Re: Agnico Eagle's response to Meadowbank and Whale Tail 2019 Annual Report comments

The following information are intended to address regulator's comments regarding the Meadowbank (2AM-MEA1530), the Whale Tail (2AM-WTP1830) and the Meadowbank Advanced Exploration Project (2BB-MEA1828) 2019 Annual Report. Response were provided for each comment as mentioned in the letter dated August 24, 2020 from NWB: *Licences No: 2AM-MEA1530, Meadowbank Gold Mine Project; 2AM-WTP1830, Whale Tail Pit Project; and 2BB-MEA1828, Meadowbank Advanced Exploration Project; Agnico Eagle Mines Limited; 2019 Annual Report Review*. Agnico would like to inform the NWB that complete submission of Agnico Eagle's responses to all the comments received from regulators, as detailed in letter mentioned below, can be found on the NIRB Public Registry.

1 Kivalliq Inuit Association (KivIA)

Figure 1. Pond Operational Guideline for Mammoth Lake

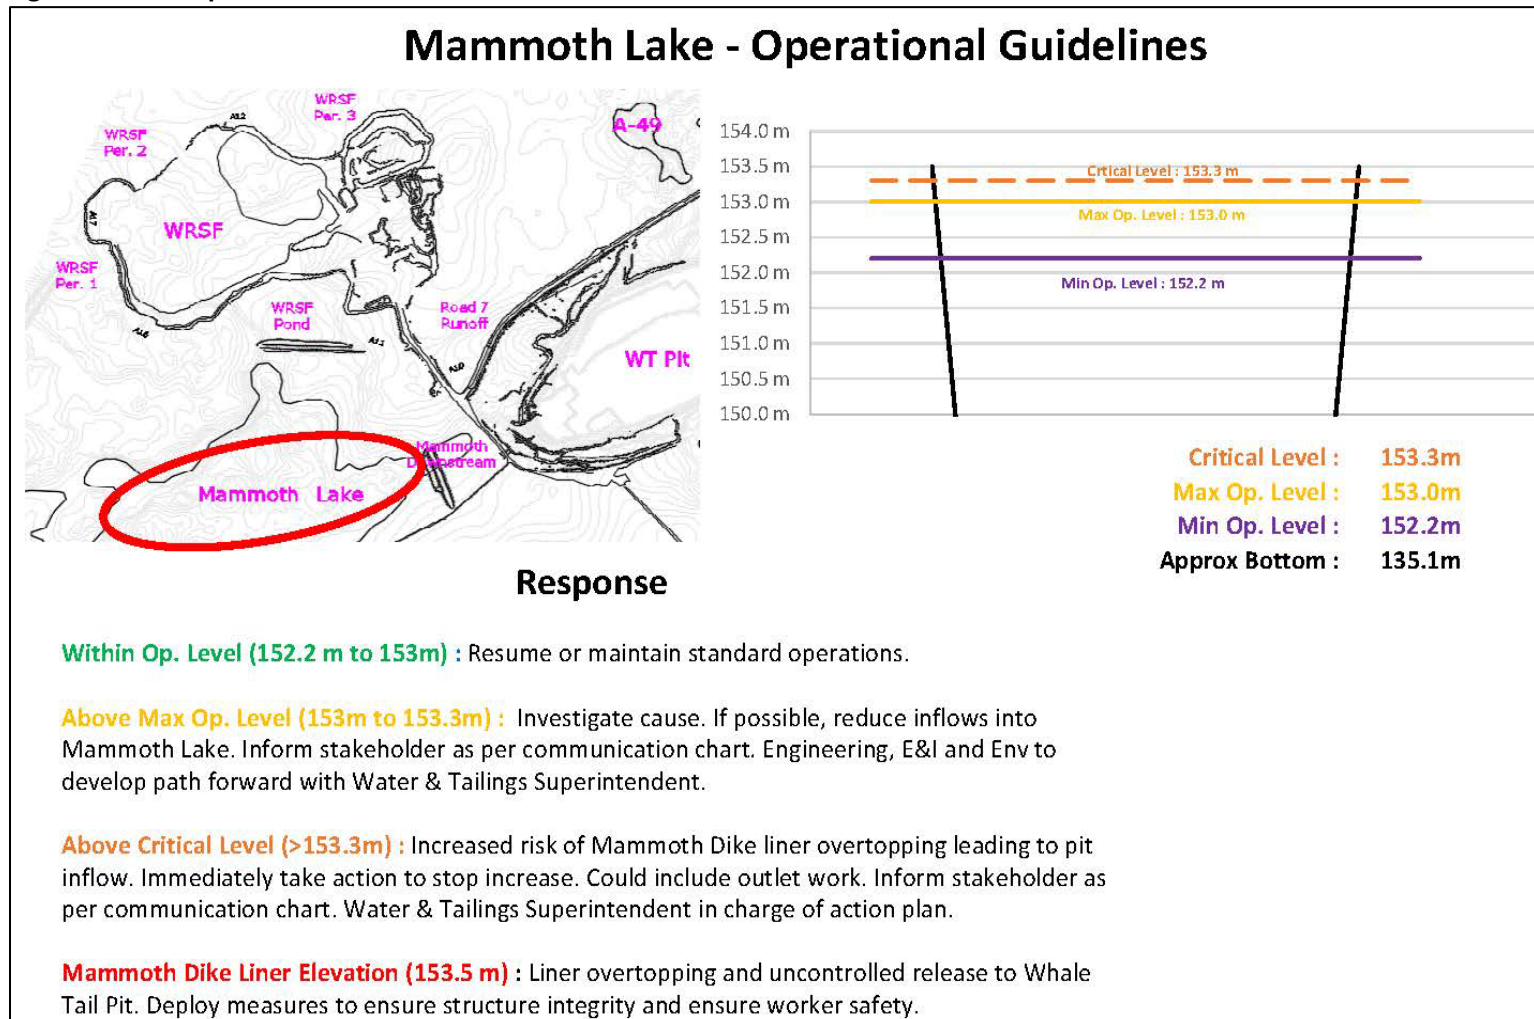
Recommendation 2: Please adaptive management thresholds, triggers and responses pertaining to water levels in Mammoth Lake, and incorporate these into the Adaptive Management Plan for the Whale Tail site.

Pond operational guidelines have been developed for the lakes and ponds at the Whale Tail site to ensure that freeboard is respected during operation. All pond operational guidelines will be included in the next version of the Whale Tail Water Management Infrastructure OMS Manual. Figure 1 is the pond operational guideline for Mammoth Lake.
